R. E. Ginna Nuclear Power Plant
Renewed Facility Operating License No. DPR-18
NRC Docket No. 50-244

Subject: License Amendment Request to Add a One-Time Note for Use of Alternate Residual Heat Removal Methods

Attachment 1
Evaluation of Proposed Change

Figure 1
Normal RHR Cooling

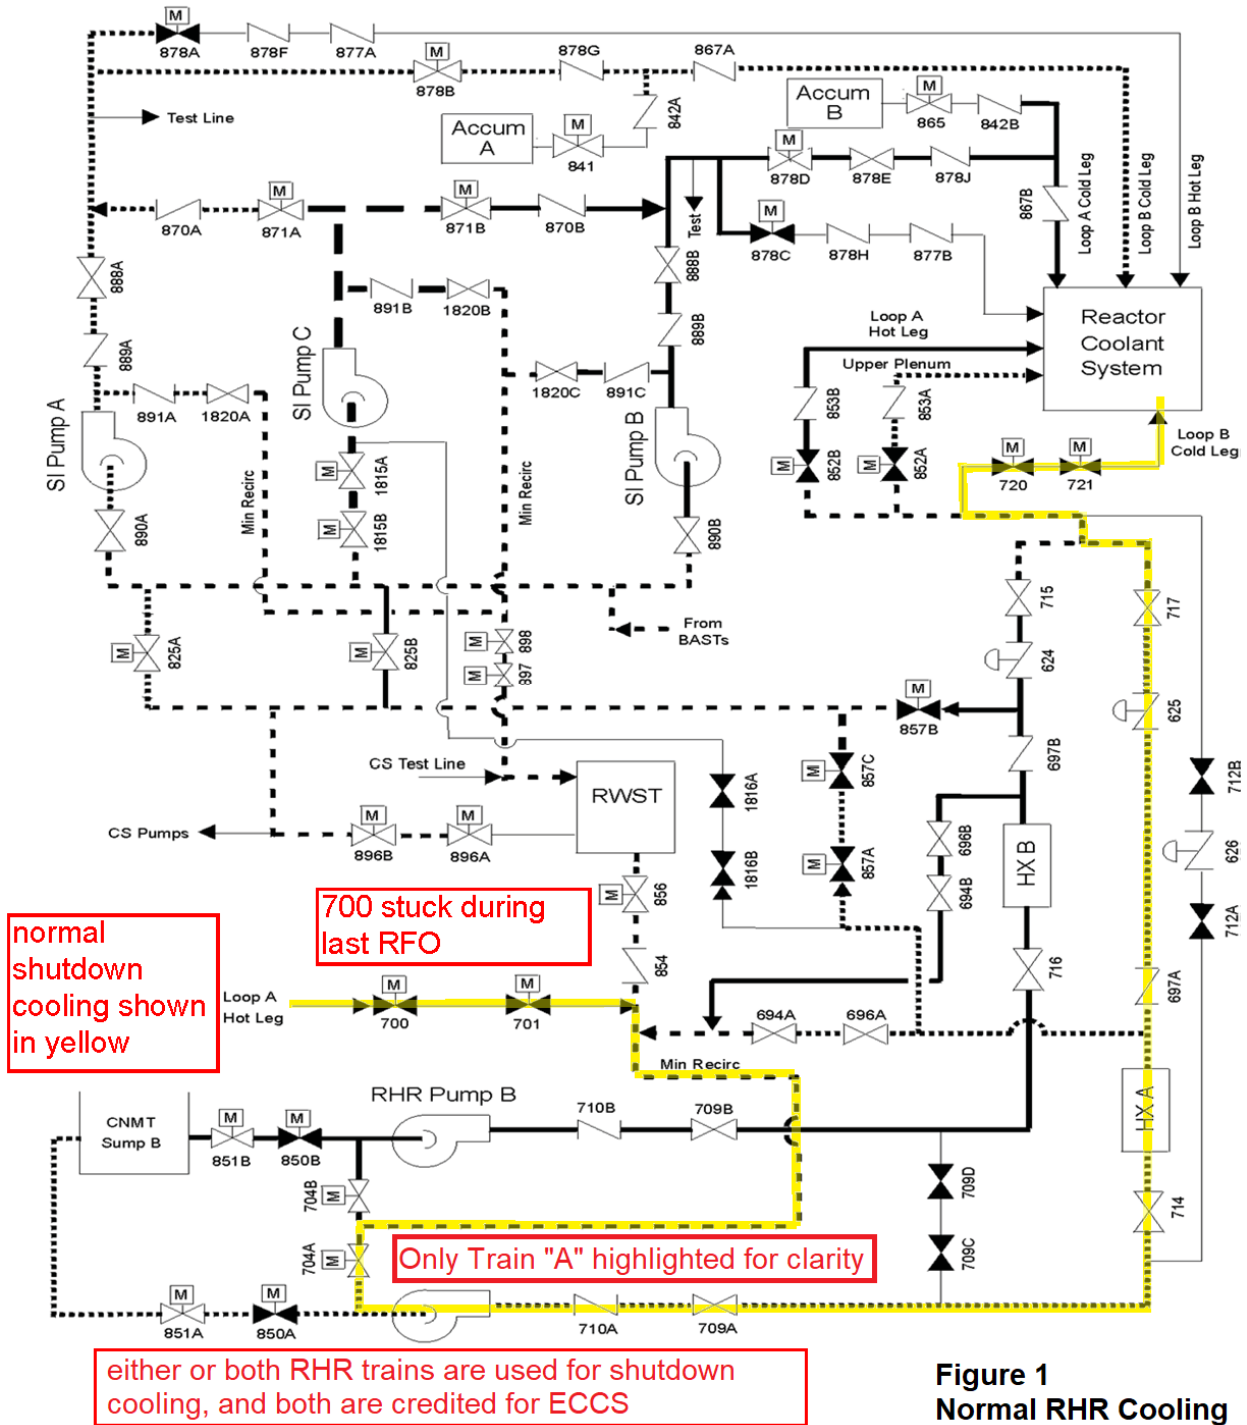
Due to concerns over the opening of the Motor Operated Valve (MOV) 700 (Figure 1 in the Technical Evaluation) associated with the operation of the Residual Heat Removal (RHR) system, this one-time change is being requested to provide an alternate form of plant cooldown which may be needed during the shutdown of the reactor during the upcoming refueling outage scheduled for April 2020.

Following the isolation of the RHR system during heat up from the 2018 refueling outage (RFO), MOV 700 was closed. Normally, the valve is re-opened as part of the interlock and leakage testing subsequent to the isolation; however, during the startup, the testing was delayed. While attempting to reopen the valve, the additional time is likely to have caused heating and distortion of the valve disc resulting in additional thrust required to open the valve. Mitigation strategies to eliminate this potential cause are in place to ensure the valve opens. MOV 701 does not experience heating from the RCS following closure, and as a result is not susceptible to the same mechanism of uneven heating and distortion that prevented opening MOV 700 during heatup from the 2018 refueling outage. In case this is not the only cause for the valve to not open and another failure mechanism is contributing to the increased required thrust to open the valve, other strategies are in place to assist in opening the valve. Some of the potential contributors, e.g. guide rail to disc interference, could result in partial opening of the valve. Although unlikely, a contingency strategy is desired to allow completion of the cooldown and removal of fuel from the reactor to enact repairs on this valve that is un-isolable from the RCS A hot leg. MOV 700 will be refurbished this upcoming outage.

Figure 2
Alternate RHR Cooling #1

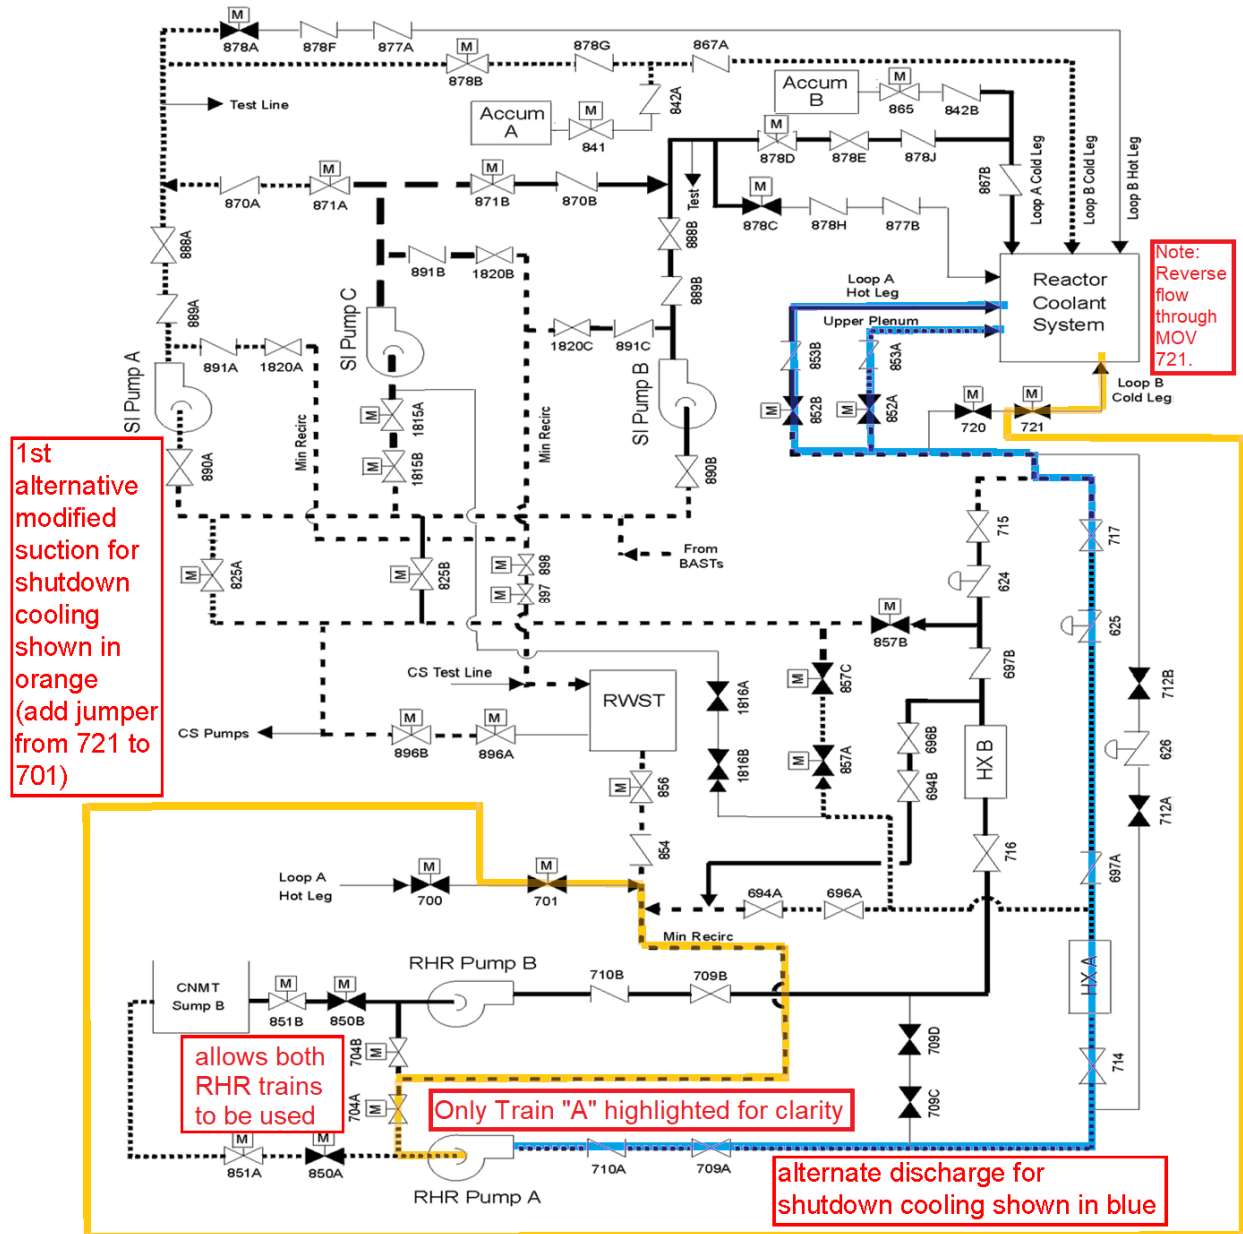
The proposed changes will ensure that a safe cooldown, from hot standby to refueling conditions, can be attained if valve MOV 700 is unable to be opened by removing residual heat by filling the steam lines with water and using the SGs as water-to-water heat exchangers. Use of solid water SG cooldown method was previously discussed in the Reference 2 application which was subsequently approved for mitigating 10 CFR 50.48 fire protection events as part of Ginna's Appendix R and NFPA 805 strategies (Reference 1). Detailed analyses of all stressors, including dead, live, and seismic forces have been evaluated to remain within code allowable values. Following use of water-solid cooldown, an alternate RHR method will employ a combination of components within the existing normal RHR loops, additional piping, fittings, hoses, and connections meeting safety-related Class 1 or 2 standards and portions of the low pressure ECCS injection system.

Water-solid SG cooldown is accomplished by lining up a condensate pump to the main feedwater line and controlling flow to fill the steam lines full of water. The Steam Generators will act as water-to-water heat exchangers with the RCS. One Reactor Coolant Pump will remain operational to maintain circulation, enhancing heat exchange efficiency and maintaining proper boric acid mixing in the RCS. Proper shutdown boric acid concentration will have been achieved prior to initiating water-solid SG cooldown. Throughout this evolution, condensate flow will be controlled, circulating water from the condensate tanks and rejecting heat in the condenser and condensate cooler to the Circulating Water System. One of the three condensate pumps will be used at a time, and the motor-driven Auxiliary Feedwater (AFW) and SFAW pumps will remain available as backups.

Figure 3
Alternate RHR Cooling #2

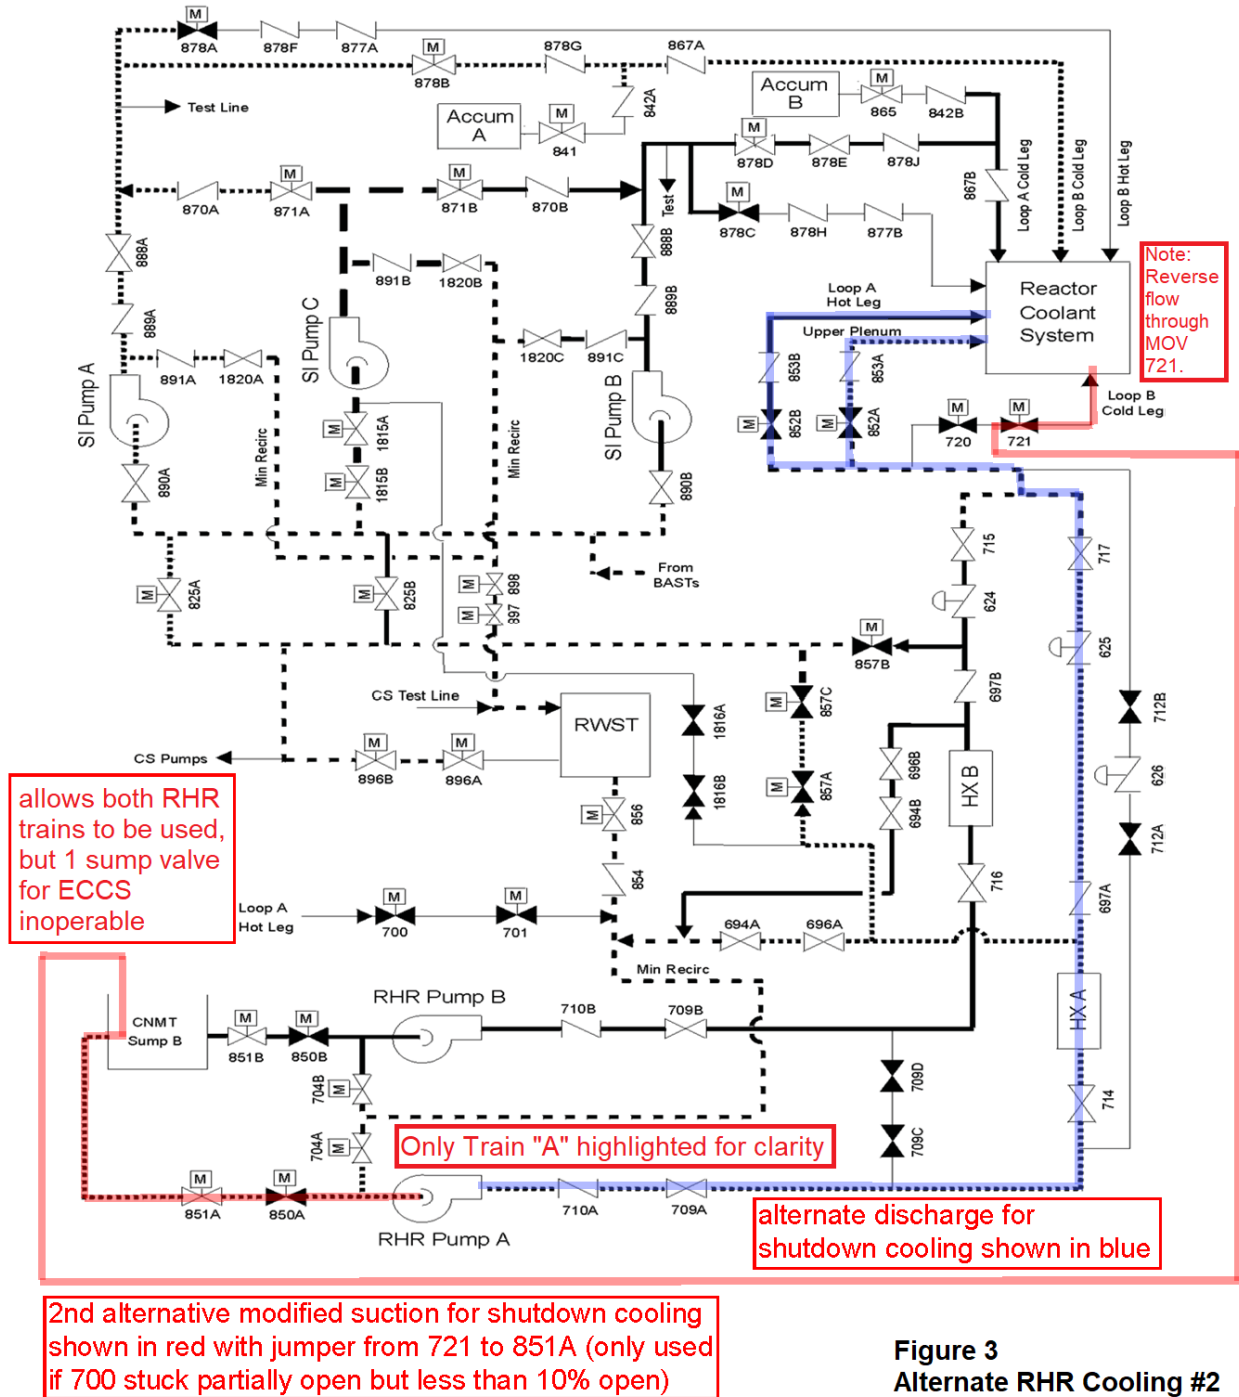
The proposed methods of cooldown to "MODE 5, loops filled" are the water solid Steam Generator cooldown method (for as long as it is effective) or the proposed alternate RHR method. This water solid Steam Generator method involves removing residual heat by filling the steam lines with water and using the Steam Generators as water-to-water heat exchangers. This method was previously discussed in the Reference 2 application which was subsequently approved for mitigating 10 CFR 50.48 fire protection events as part of Ginna's Appendix R and NFPA 805 strategies (Reference 1). When the Steam Generator cooldown method is no longer effective ("MODE 5, loops not filled"), another proposed method will provide an alternate RHR loop using primarily the low-pressure Emergency Core Cooling System flowpath (Figure 2 in the Technical Evaluation). In order to implement this method, additional piping, fittings, connections, and hoses will need to be added. These additional components will be designed, procured, installed, and tested to rigorous standards, consistent with safety-related Class 1 or Class 2 components, as appropriate. Another contingency method has been developed, in the small possibility that MOV 700, when opening is attempted, will only open far enough to come off its seat, i.e., not enough to be a viable cooldown method flowpath but enough that it could no longer be considered an isolation boundary. For this eventuality, alternate cooling will be provided by an alternate loop from the Reactor Coolant System (RCS) to the suction of the RHR pumps and then via low pressure ECCS flowpaths (Figure 3 in the Technical Evaluation).

Prior to water-solid SG cooling becoming ineffective, an alternate means will be implemented. RCS will be routed from the loop B cold leg, through newly installed piping, fittings, hose, and connections all meeting safety-related Class 1 or 2 criteria as appropriate, to the suction of the RHR pumps via connection between valves 700 and 701. Flow will then be routed to the reactor vessel upper plenum injection nozzles via the normal low pressure ECCS flowpath. In the small possibility that MOV 700, when opening is attempted, will only open far enough to come off its seat (i.e., not enough to be a viable cooldown method flowpath but enough that it could no longer be considered an isolation boundary) RCS will be routed from the loop B cold leg, through newly installed piping, fittings, hoses, and connections to the suction of the RHR pumps via a connection upstream of MOV 851A. Flow will then be routed to the reactor vessel upper plenum injection nozzles via the normal low pressure ECCS flowpath.
